**CITY OF BOULDER
PLANNING BOARD MEETING AGENDA**

A. Continuation: Public hearing to consider Concept Plan, LUR2013-00058, for the redevelopment of a 3-acre site located at the intersection of Baseline Rd. and 27th Way with a new four story, 180,000 square foot office building and a 70,000 square foot, 100-room hotel. The site is zoned Business Community- 2 (BC-2).

CITY OF BOULDER
PLANNING BOARD AGENDA ITEM
MEETING DATE: January 16, 2014

AGENDA TITLE: Public hearing to consider **Concept Plan**, LUR2013-00058, for the redevelopment of a 3-acre site located at the intersection of Baseline Rd. and 27th Way with a new four story, 180,000 square foot office building and a 70,000 square foot, 100-room hotel. The site is zoned Business Community- 2 (BC-2).

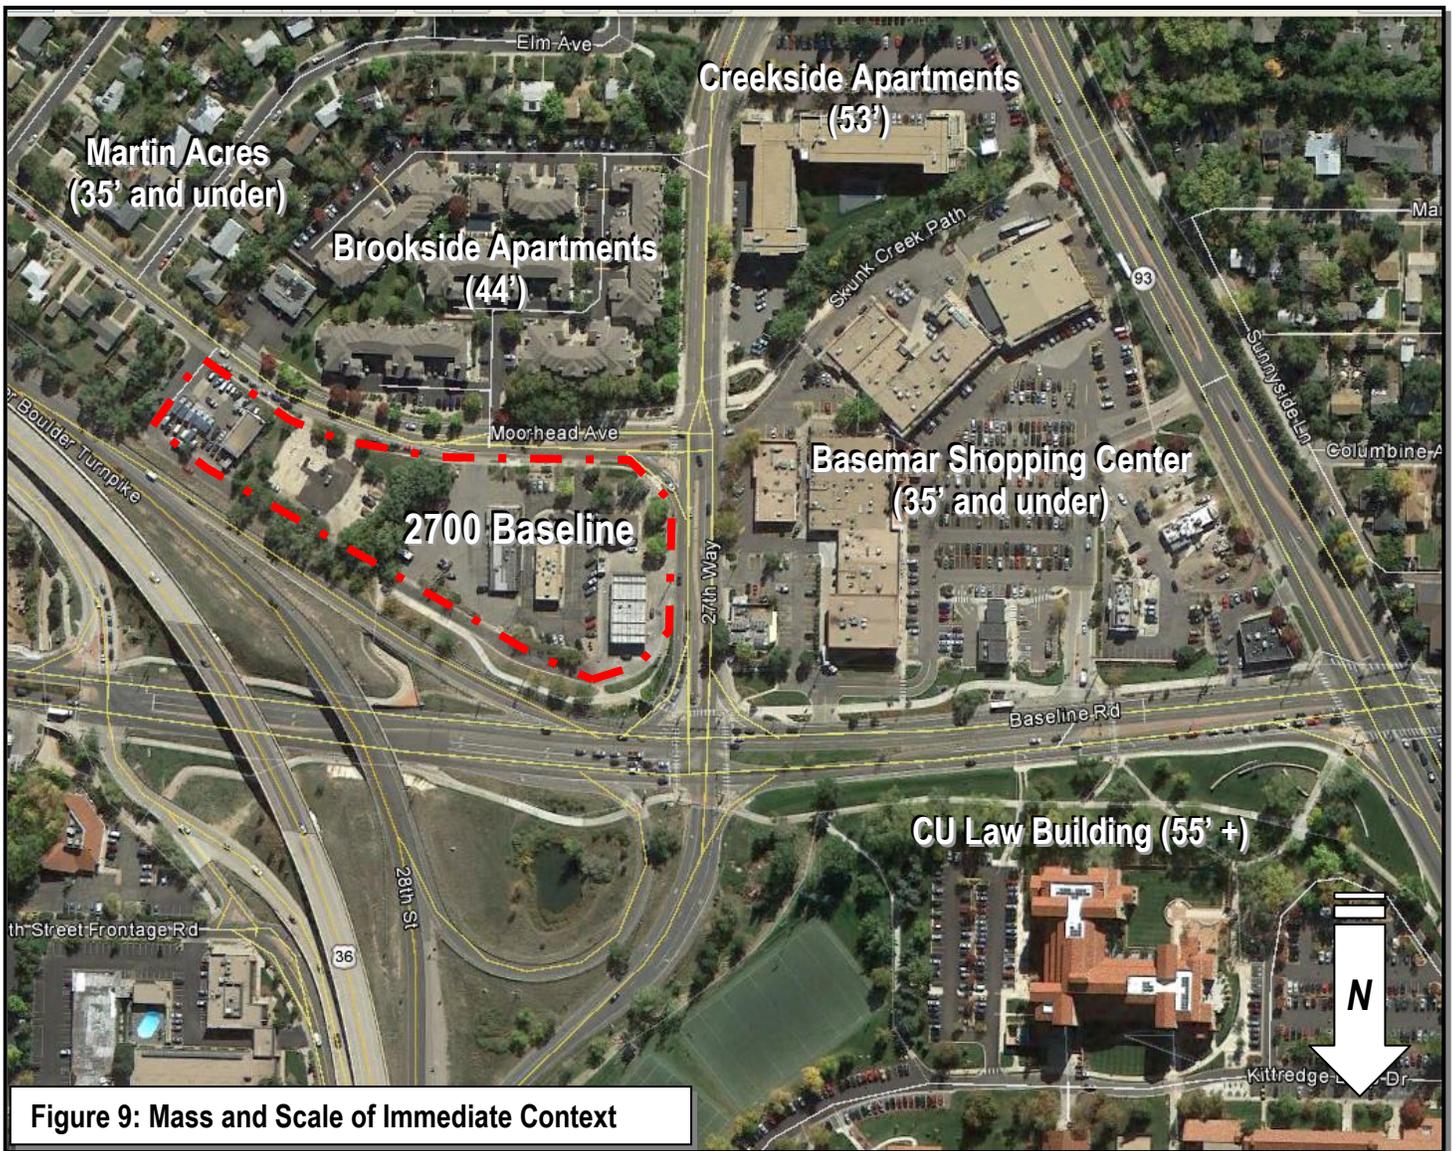
As shown in **Figure 9** below, the existing context surrounding the site is varied in terms of building mass and scale. While the residential structures to the east of the site are all under 35 feet in height and the Basemar shopping center to the west is also comprised of one and two-story buildings 35 feet in height and under, the proposed 45’ hotel and 54’ office building are not atypical for the immediate area, as the site is backdropped on the south and west by similarly tall structures that include the 45-foot tall Brookside Apartments to the south and the 53-foot tall Creekside Apartments across 27th Way to the West. There are also a number of taller buildings across Baseline to the north, lying on the CU campus and along the east side of U.S. 36. As the project plans progress, it will be important to provide images to adequately assess the massing and scale of the project through visual simulations to evaluate the fit of the building design and intensity into the context. Given the range in the mass and scale of nearby buildings, special care should be taken as the project progresses to provide an

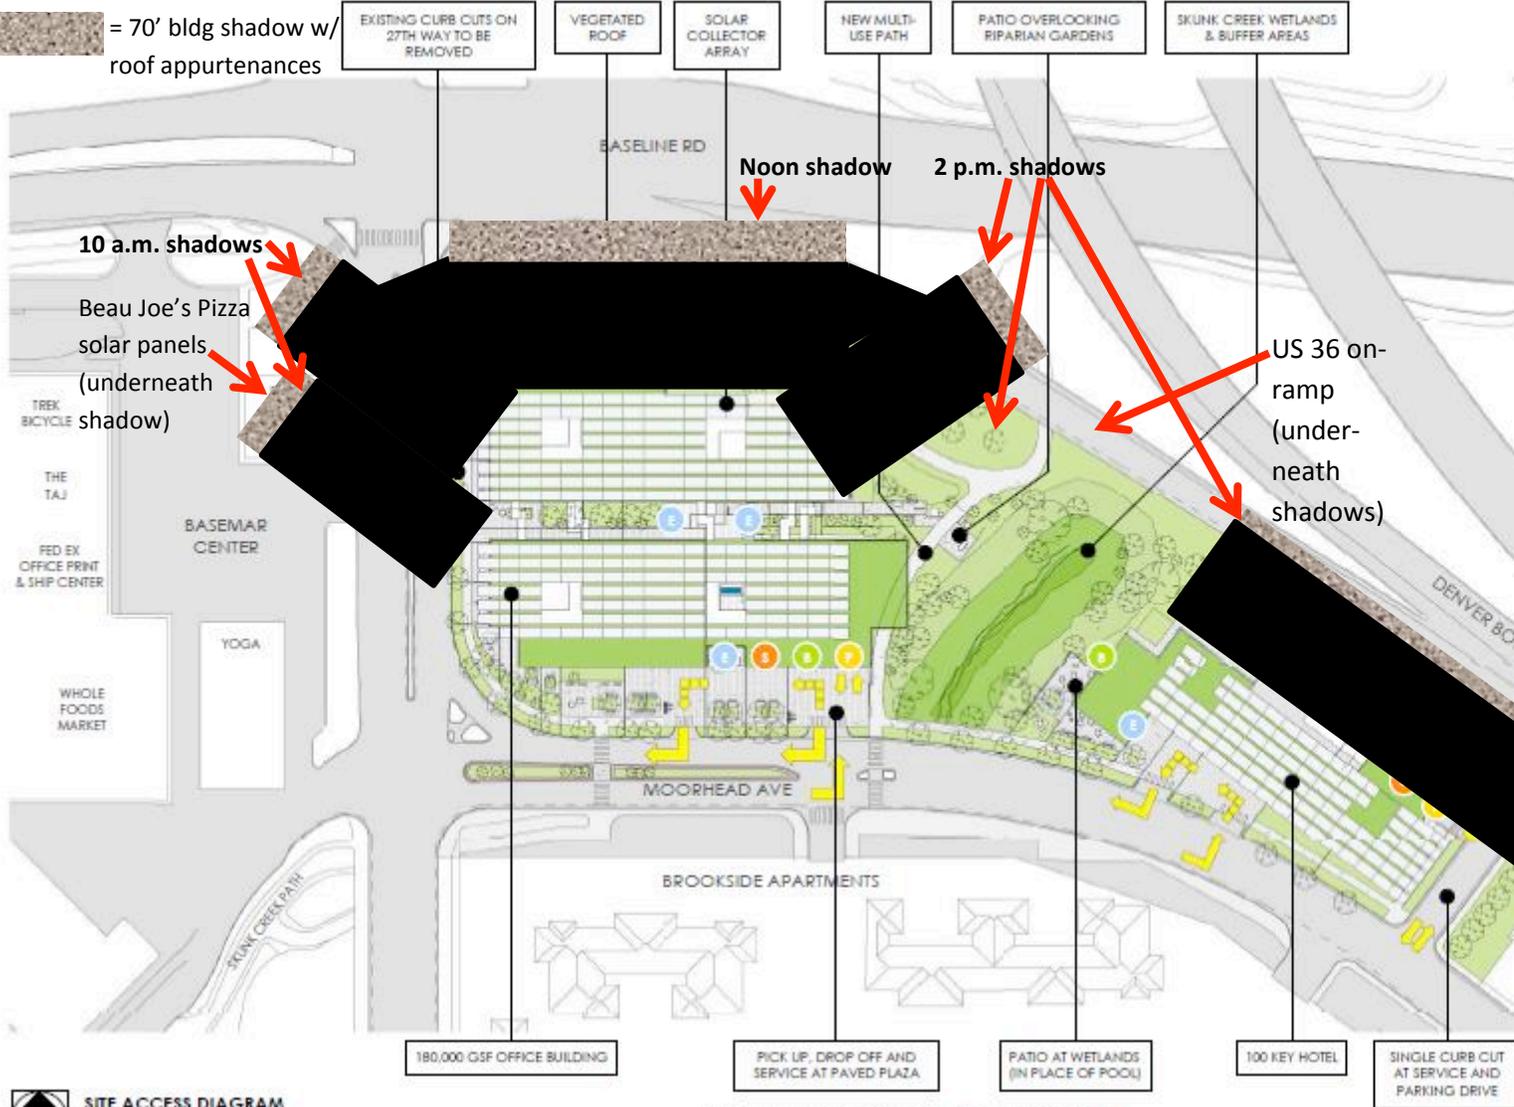
Looking up from Skunk Cree bike path at Brookside Apts. 95% of snow covered ground is below street level. Pictured: Bldg. B, 32.9' in height

Looking north toward Moorhead. Human subject here, same location, well below street level. This 10' to 12' of elevation loss "below street level" at Brookside should not count as its "height" compared to Baseline Zero. B Zero will be 100% above street level.

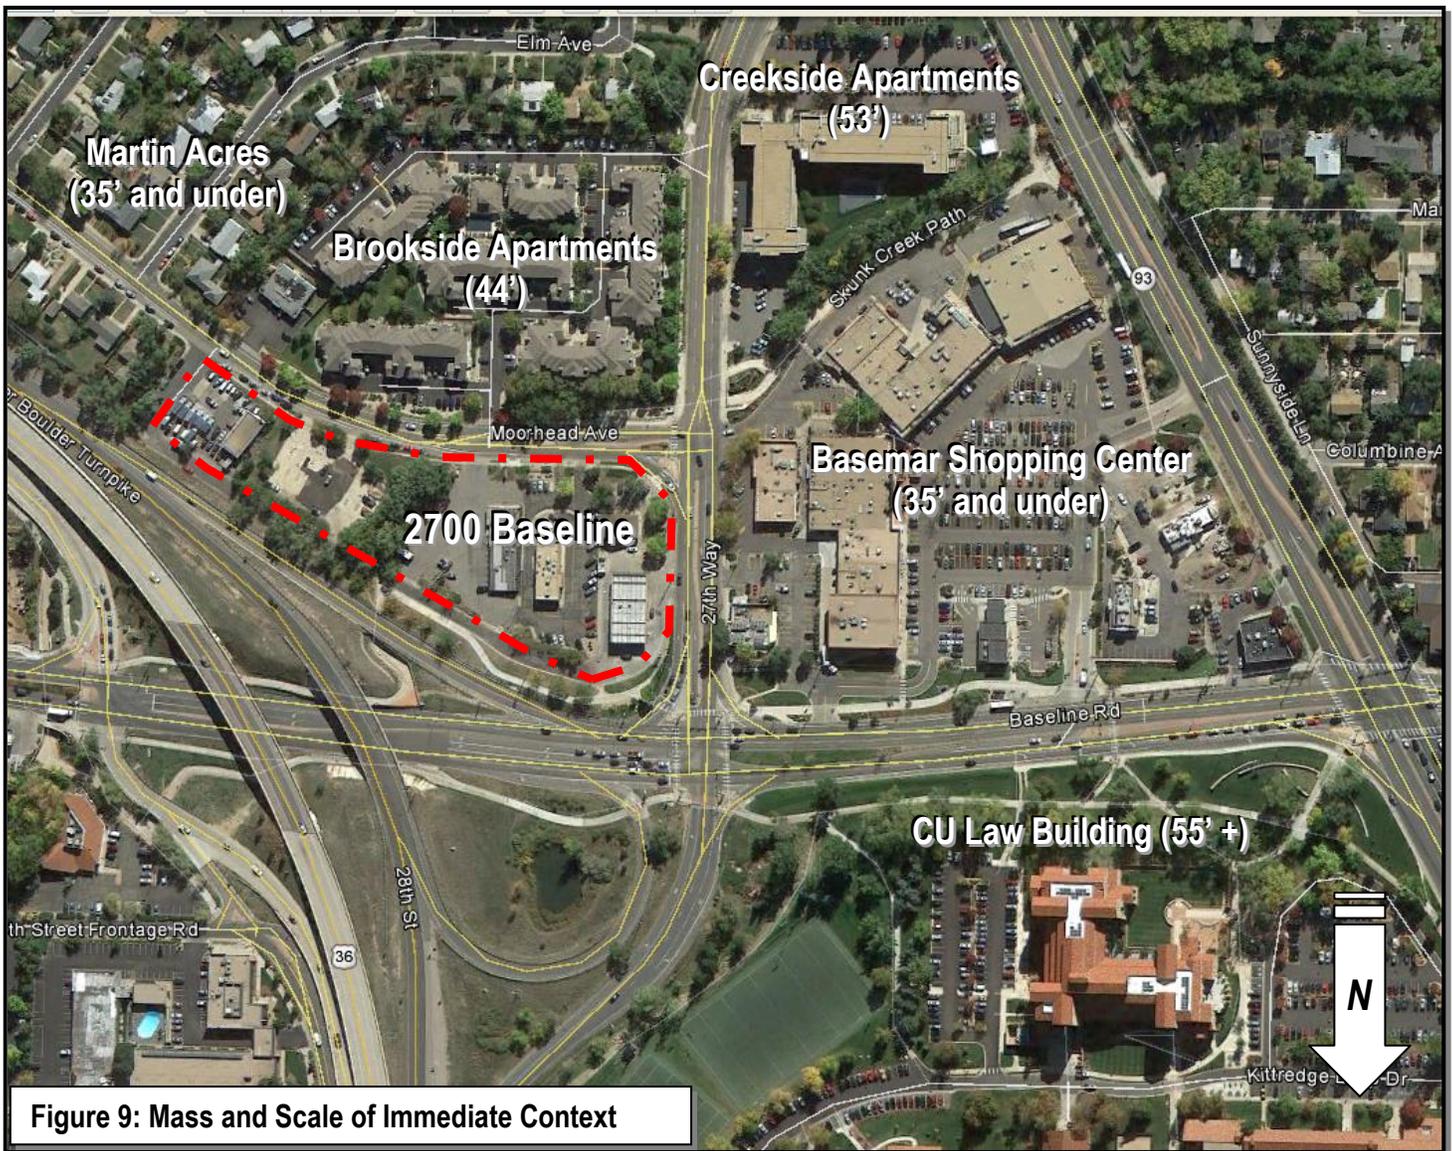
As shown in **Figure 9** below, the existing context surrounding the site is varied in terms of building mass and scale. While the residential structures to the east of the site are all under 35 feet in height and the Basemar shopping center to the west is also comprised of one and two-story buildings 35 feet in height and under, the proposed 45’ hotel and 54’ office building are not atypical for the immediate area, as the site is backdropped on the south and west by similarly tall structures that include the 45-foot tall Brookside Apartments to the south and the 53-foot tall Creekside Apartments across 27th Way to the West. There are also a number of taller buildings across Baseline to the north, lying on the CU campus and along the east side of U.S. 36. As the project plans progress, it will be important to provide images to adequately assess the massing and scale of the project through visual simulations to evaluate the fit of the building design and intensity into the context. Given the range in the mass and scale of nearby buildings, special care should be taken as the project progresses to provide an
